TECHNICAL BULLETIN

FUJI HEAVY INDUSTRIES LTD.

NO. 200-017 DATE 62-2-26 (SUPERSEDES NO.)
REV. DATE (SUPERSEDES NO.)
REASON

1. SUBJECT : Canopy Rear Roller Rail Wear, Repair of
2. AIRCRAFT AFFECTED : FA-200 S/N 12 through 214
3. PRIORITY : Optional
4. REASON : To provide a repair scheme for wear at the canopy rear roller.
5. DESCRIPTION : If repair is required by inspection, rework canopy rail worn area and install additional roller.
6. ACCOMPLISHMENT : At customer's option
7. APPROVAL : Not required
8. PARTS REQUIRED : If additional roller is required, the following parts are required per side.

FIGURE 1. REWORK OF WEAR AT CANOPY REAR ROLLER RAIL

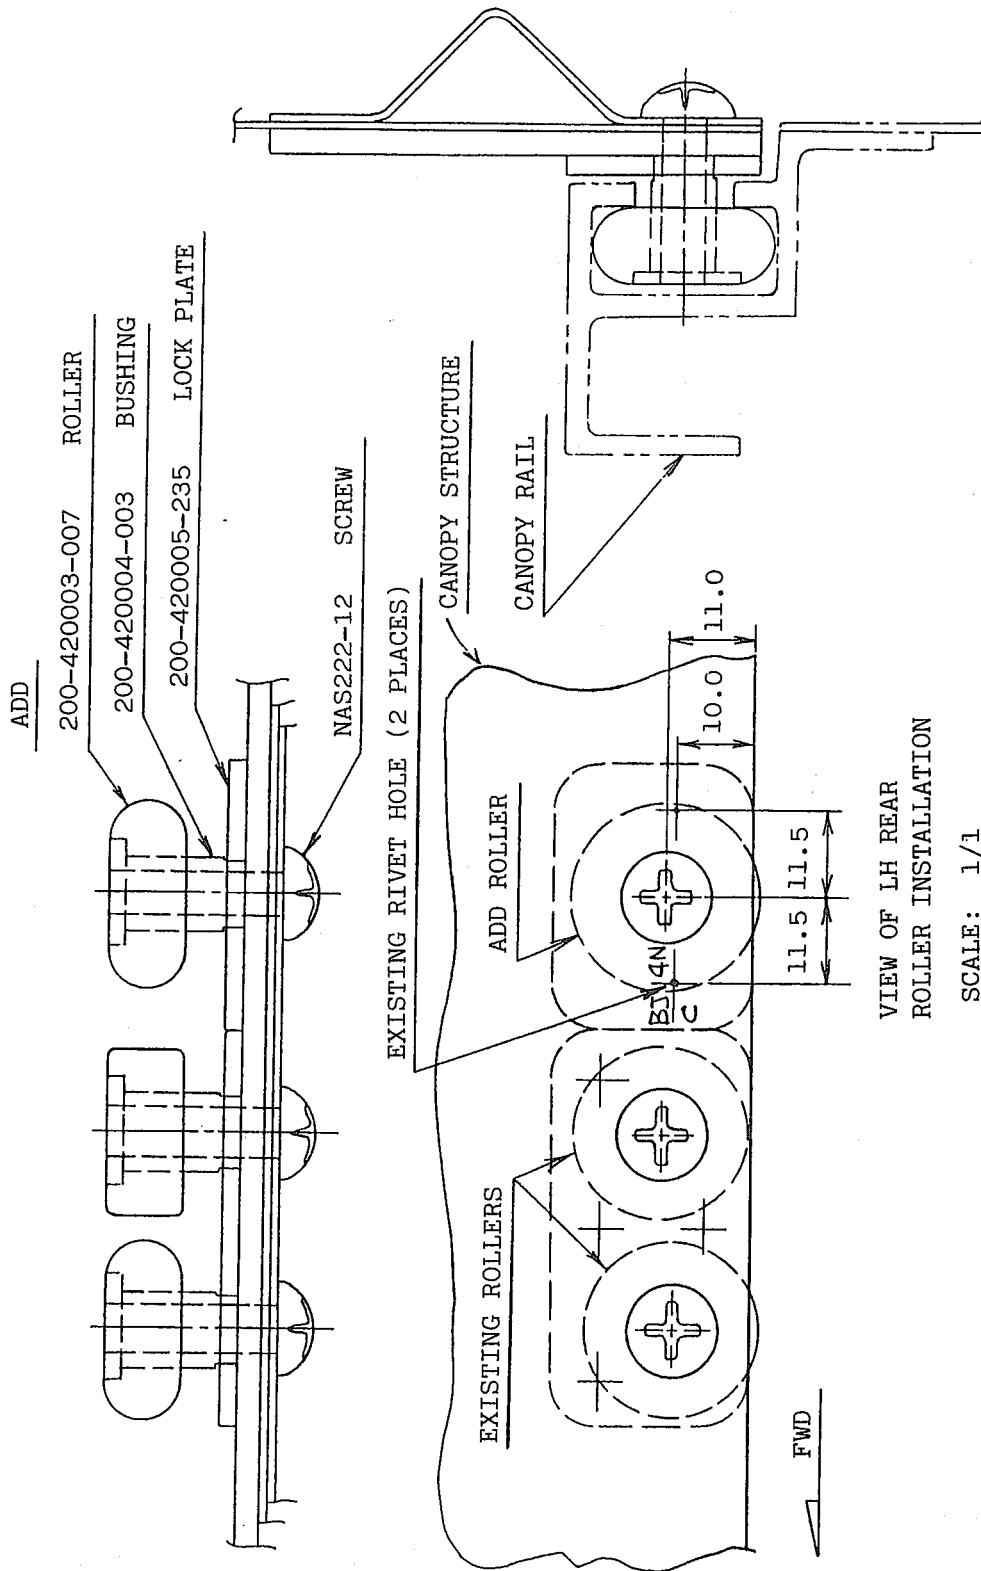
9. SPECIAL TOOL : None required
10. WEIGHT AND BALANCE: Negligible
11. REFERENCE : Not applicable
12. ACCOMPLISHMENT INSTRUCTIONS:
 - (1) Fully close canopy.
 - (2) With a suitable marking pen, mark the portion of canopy rail which is aligned with canopy rear roller position.
 - (3) Fully open canopy.
 - (4) Inspect the marked portion of canopy rail for wear. (see figure 1.) If wear is found, remove canopy in accordance with FA-200 Service Manual, Paragraph 7-4-1. Rework the worn area smoothly as indicated on Figure 1. (Remove material minimum as required.)

- (5) If rail flange material (dimension "a" on Figure 1, View A-A) is completely removed, after rework of excessively worn area, additional installation of roller is required in accordance with the following steps (6) through (8). Even if material removed is less than the above, add roller if lateral (axial) play is excessive.
- (6) Attach lockplate (200-420005-235) to canopy as shown in Figure 2.
- (7) Remove canopy rail stop. Install bushing (200-420004-003) into roller (200-420003-007). Engage the bushing and roller in rail, and then reinstall rail stop.
- (8) Reinstall canopy in accordance with FA-200 Service Manual, Paragraph 7-4-2. Secure the added roller in the same manner as the existing two rollers.
